The Town of Hilton Head Island
Design Review Board Regular Meeting
Tuesday, September 24, 2019 – 1:15 p.m.
Benjamin M. Racusin Council Chambers
AGENDA

Northridge Plaza Site Improvements and Building Façade Upgrades

DESIGN TEAM/DRB COMMENT SHEET

OVERALL FRONT ELEVATION

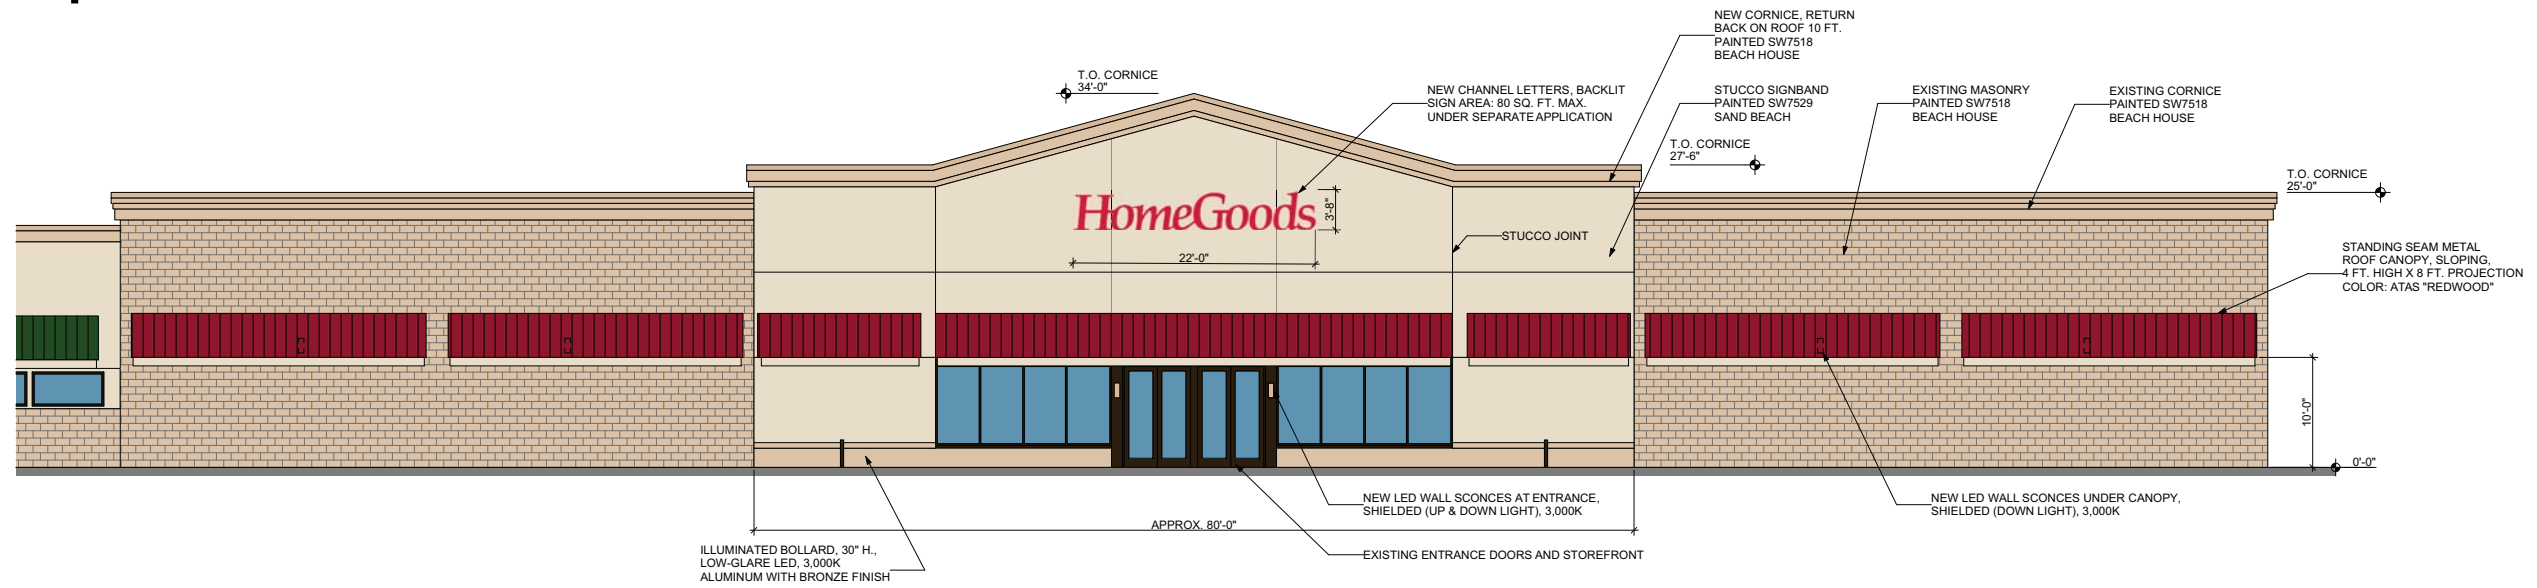
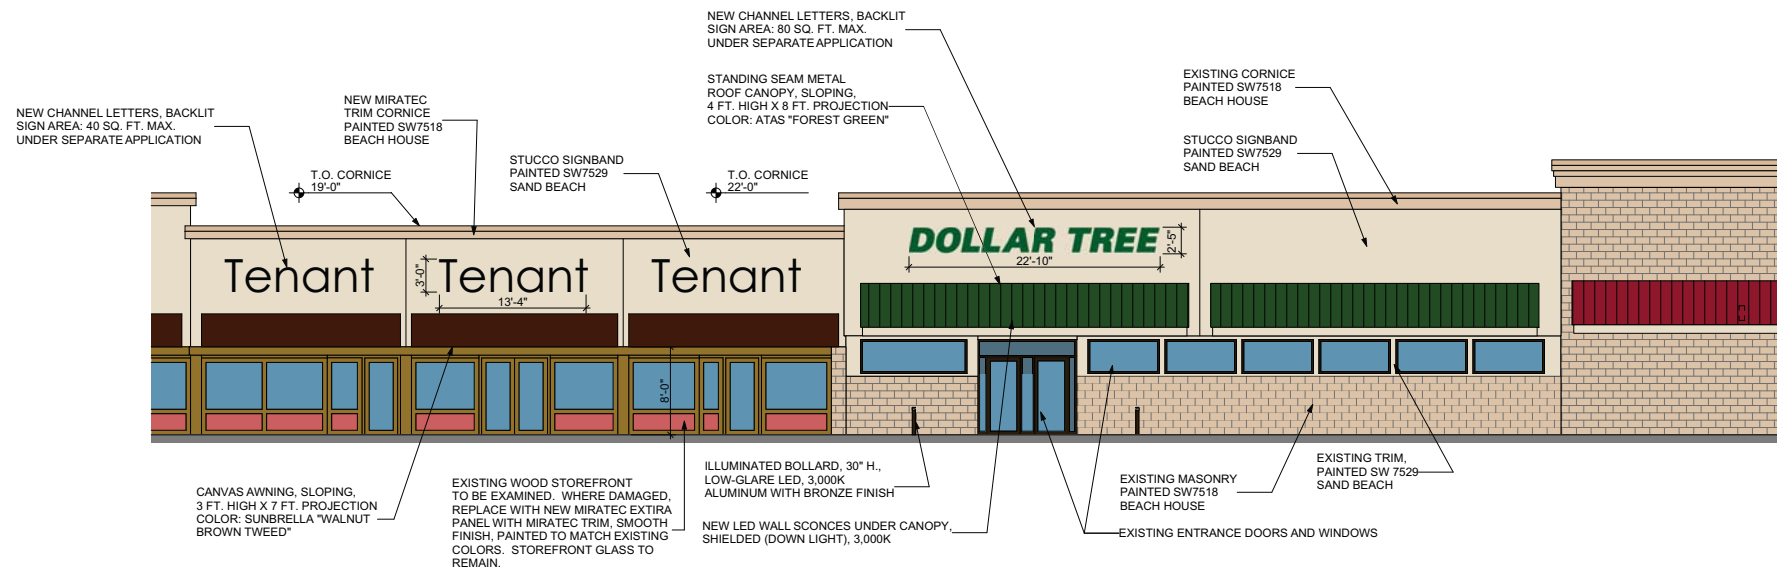
that is behind it. The proposed canopy at Home Goods and Dollar Tree is not deep enough and its roof large enough to soften the wall behind it. Staff suggest that columns be added to the canopy and or the addition of other architectural detail to the back wall. How will the blank walls be treated where the building steps back, i.e., between space 10 and 9 and the Dollar Tree and space 3A.
Design is unobtrusive and set into the natural environment	<input type="checkbox"/>	<input checked="" type="checkbox"/>	<input type="checkbox"/>	The proposed awnings at Home Goods and Dollar Tree are not nature blending colors and do not coordinate with the balance of the center. A physical color board will need to be submitted to adequately review the proposed materials, colors and finishes. The color of the metal roof canopies should be consistent and relate to the building color scheme and not the current tenants brand colors.

CANOPY SECTION

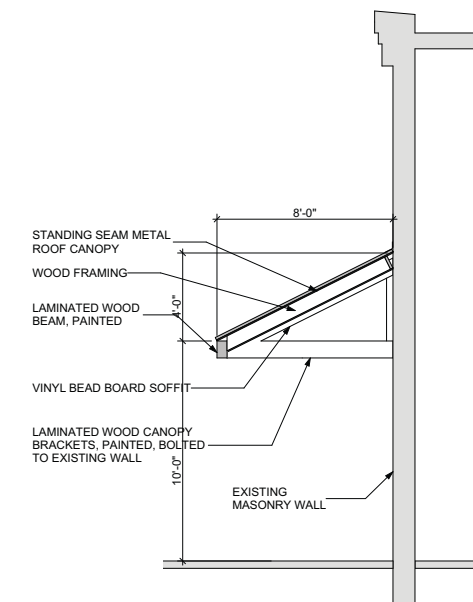
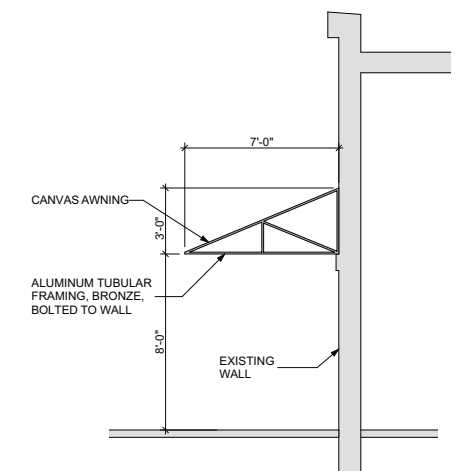
<i>APPLICATION MATERIAL</i>				
DRB REQUIREMENTS	Complies Yes	No	Not Applicable	Comments or Conditions
Demolition Plan if needed	<input type="checkbox"/>	<input checked="" type="checkbox"/>	<input type="checkbox"/>	Provide a Demolition Plan that clearly identifies everything to be removed. How will the existing pedestrian canopy on the adjacent building (movie theater) be treated once the proposed demolition is complete.
Dimensioned Details and of Sections	<input type="checkbox"/>	<input checked="" type="checkbox"/>	<input type="checkbox"/>	Provide detail of the proposed façade additions
Detail Illustrating Connection to Existing Structure	<input checked="" type="checkbox"/>	<input checked="" type="checkbox"/>	<input type="checkbox"/>	Provide detail of the proposed awnings and how they connect to the building

Utilizes natural materials and colors	<input checked="" type="checkbox"/>	<input checked="" type="checkbox"/>	<input type="checkbox"/>	The proposed stacked stone façade is not a material native to the island and is not in keeping with “Island Character”.
Avoids monotonous planes or unrelieved repetition	<input type="checkbox"/>	<input checked="" type="checkbox"/>	<input type="checkbox"/>	The repetition beyond Dollar Tree could be broken up with color (at a minimum), additional treatment of the “tower” elements or variation of / in the awning system.
Has a strong roof form with enough variety to provide visual interest	<input type="checkbox"/>	<input checked="" type="checkbox"/>	<input type="checkbox"/>	The strong roof form has been eliminated at Home Goods.
Overhangs are sufficient for the façade height.	<input checked="" type="checkbox"/>	<input checked="" type="checkbox"/>	<input type="checkbox"/>	Provide a sections of the new canvas awnings proposed.
